Errata Sheet

Product Family: DL305
Manual Number: D3-USER-M
Revision and Date: 1st Edition, Rev. D; January 2010

Date: August 2018

Page 2-12. Base Wiring

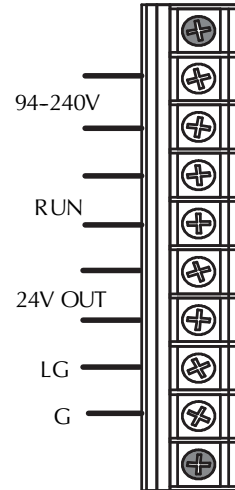
On newer 110-240 VAC bases, the terminal strip has been re-designed and does not have different terminals for 110VAC and 240VAC connections. If you have one of these re-designed bases the terminal strip will look like this:

Page 3-9. DL330/DL330P CPU Setup; Installing the UV PROM Option in the DL330/DL330P CPU

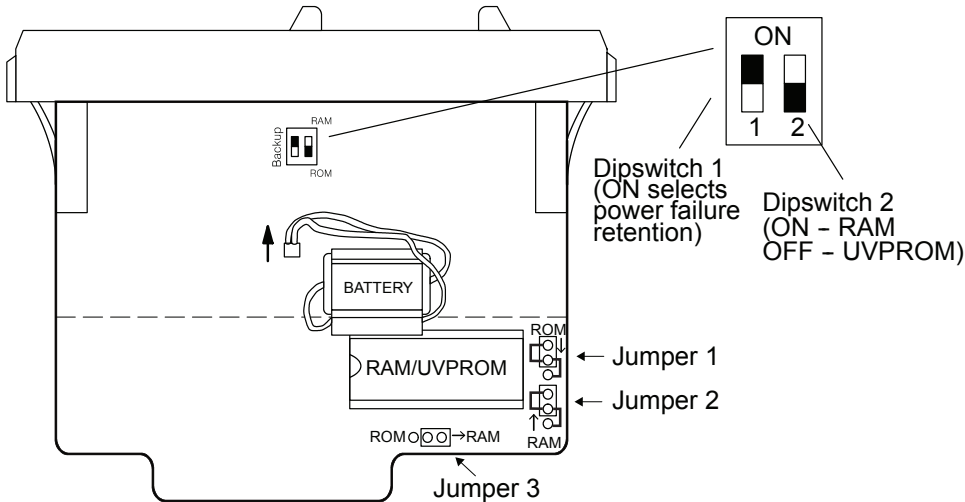
The drawing showing the jumpers is missing the silkscreen jumper lines and arrows for jumpers 1, 2 and 3. Refer to this drawing.

Page 4-16. Setting the Base Switches; 5 Slot Bases

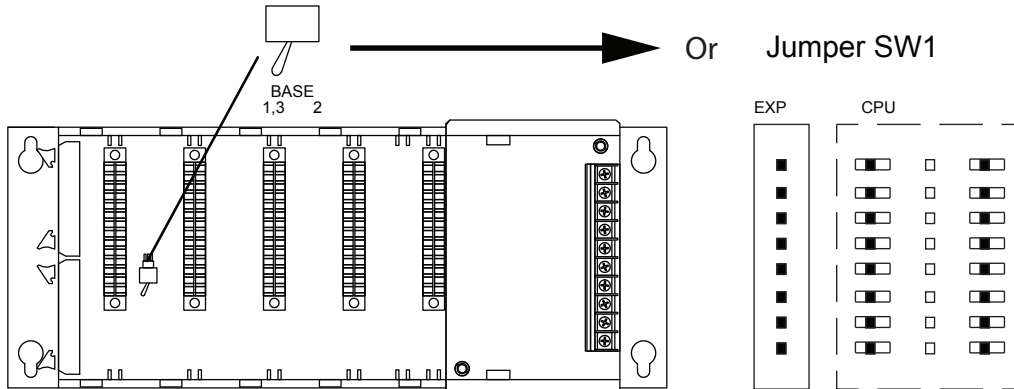
Replace the drawing of the 5 slot base with this one. Newer 5 slot bases have jumper switch SW1 instead of the toggle switch to set whether the base is a local CPU base or an expansion base.

NOTE: Older bases have a toggle switch to set the base as the CPU local base, the first expansion base, or the second (last) expansion base. Newer bases have the jumper SW1 in place of the switch.
